UNITED STATES PATENT AND TRADEMARK OFFICE

APPLICATION NO.	FILING DATE	FIRST NAMED INVENTOR	ATTORNEY DOCKET NO.	CONFIRMATION NO.
09/751,453	01/02/2001	Kee Jeung Lee	M 275264 HD943/US	7152

Office Action Summary

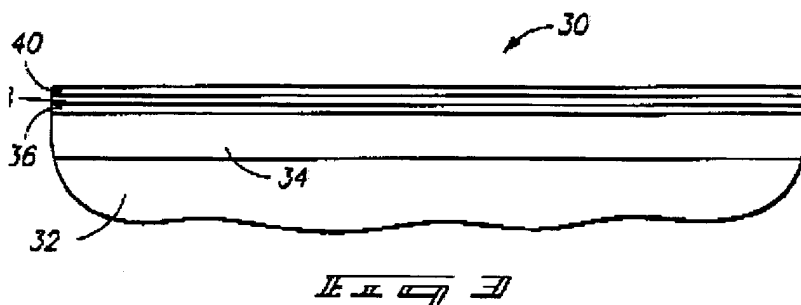
However, DeBoer in fig.3 shows

Therefore it is known in the prior art that the dielectric layer may comprise of a plurality of layers.

Referring to FIG. 3, a second tantalum-comprising layer 40 is formed over first tantalum-comprising layer 38. Sec-

ond tantalum-comprising layer 40 is a barrier layer preferably comprising tantalum and nitrogen, such as in the form Ta_2N . Second tantalum-comprising layer 40 can additionally comprise oxygen, and may, for example, comprise a compound having the general formula $Ta_xO_yN_z$.

The value for x, y, and z all being one (1) is not excluded, therefore if the value of x,y, and z is one the formula will be TaON.

It is noted that the previous rejection referred to layer (namely # 40) and layer 38 mentioned by the applicants.
